## SERVICE BULLETIN

### **B4319903**

### **431 Door Duct Cover**

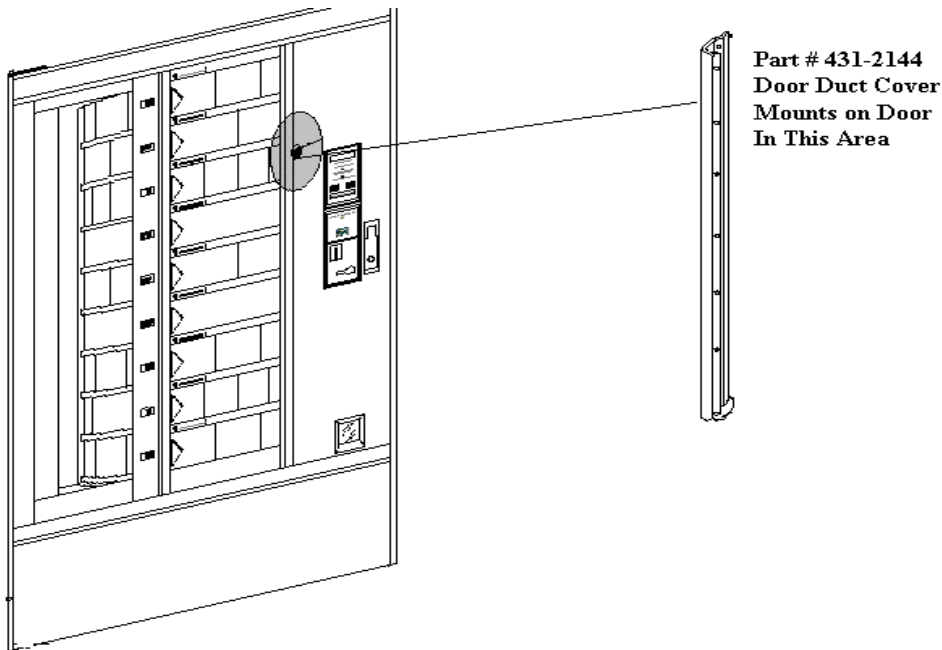
The door duct cover assembly has been modified on the 431 merchandiser in order to provide increased airflow across the product delivery doors. This should help to alleviate the buildup of condensation on the product delivery doors on merchandisers operating in locations of high humidity.

The new door duct cover part # is 431-2144 and is available through the National Vendors Part Department. This change is being implemented as a product improvement and is not recommended to update older merchandisers unless you are experiencing a condensation problem with the product delivery doors.
